Amendment to the Drawings

SWITCHABLE FLUID CONTROL VALVE
SYSTEM

Docket No.: 89190.106903 (DP-309416)

Annotated Marked-up Drawing

FIG. 3

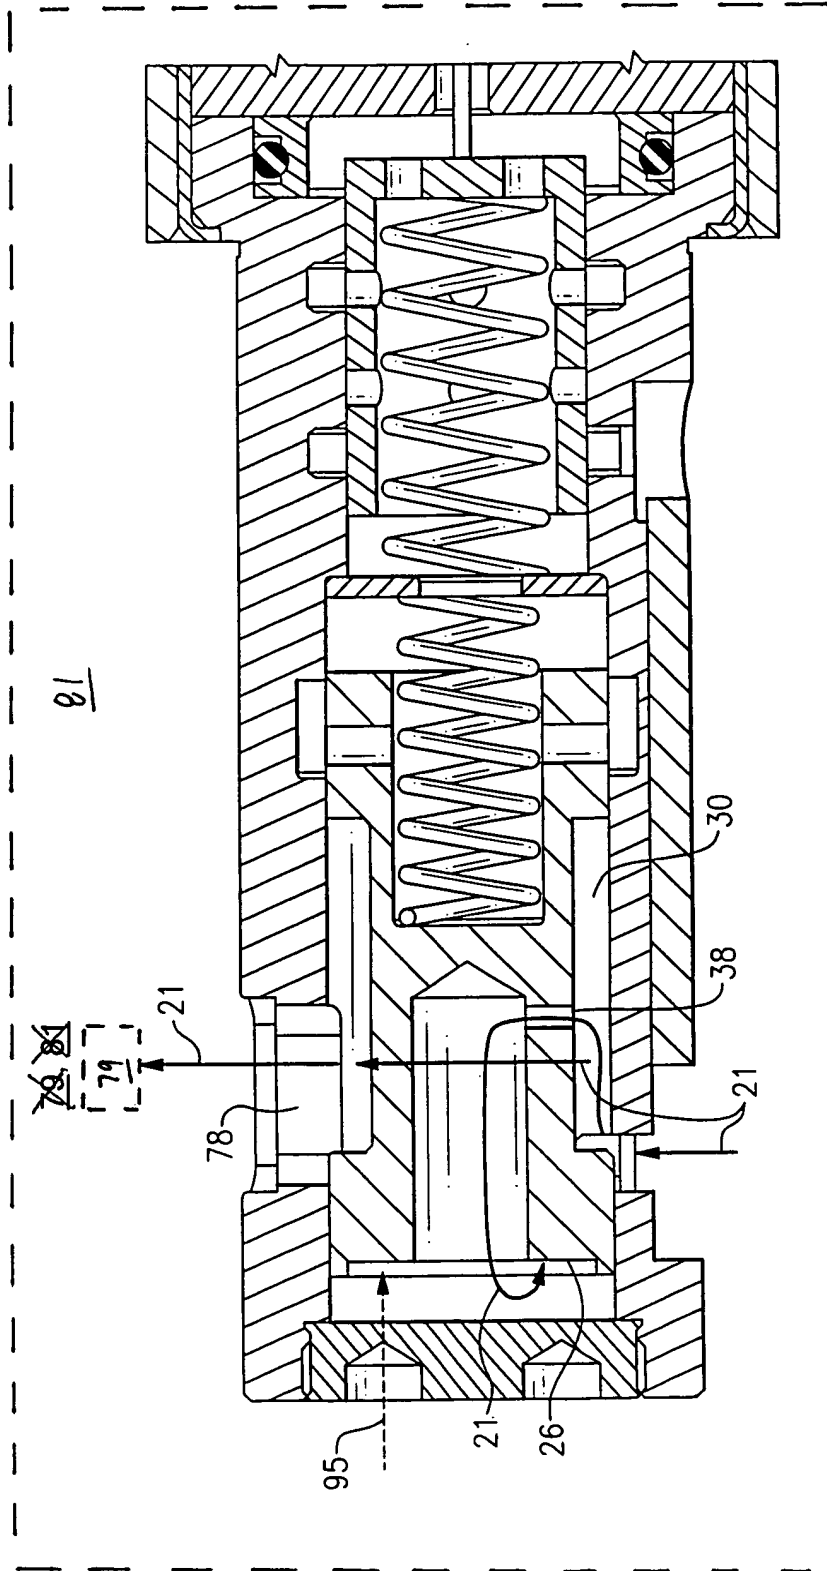
The attached drawing sheet includes a change to FIG. 3. This sheet, which includes FIG. 3, replaces the original sheet including FIG. 3. In Figure 3, the internal combustion engine (81) and the two-step valve activation mechanism (79) have been shown schematically using boxes.

The drawings were objected to under 37 C.F.R. § 1.83(a) because the drawings must show every feature of the invention specified in the claims. See *Office Action*, pg. 2. In particular, the Examiner stated that the internal combustion engine and the two-step valve activation mechanism specified in claim 10 must be shown in the drawings. See *id.* Applicant submits that the internal combustion engine and the two-step valve activation mechanism are shown in original FIG. 3 and are labeled with reference numerals 81 and 79, respectively. See FIG. 3; see also *Specification*, pg. 7, lines 6-10. In an effort to further show the internal combustion engine and the two-step valve activation mechanism in the drawings, FIG. 3 has been amended to schematically show the two-step valve activation mechanism (79) and the internal combustion engine (81). For at least the aforementioned reasons, Applicant requests that the above-referenced amendments to the drawings be entered and that the objection to the drawings be withdrawn.
